## Product Change Notification

March 12, 2019

## Bourns® Model CAT10 Series Chip Resistor Arrays *Additional Manufacturing Location to Increase Capacity*

N1909

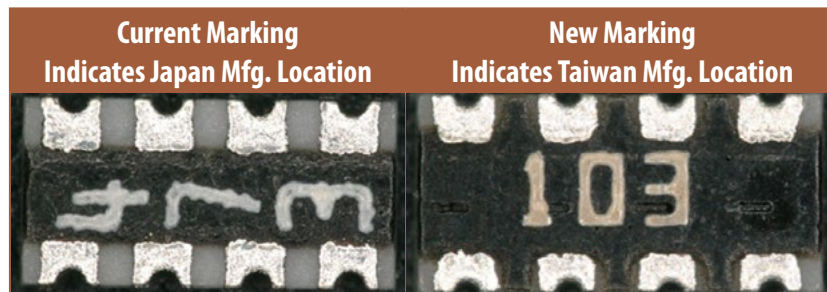
The form of the product from the new Taiwan location will change with the addition of the new manufacturing location.

Users should verify that the described changes will not impact the performance of the product in their specific applications.
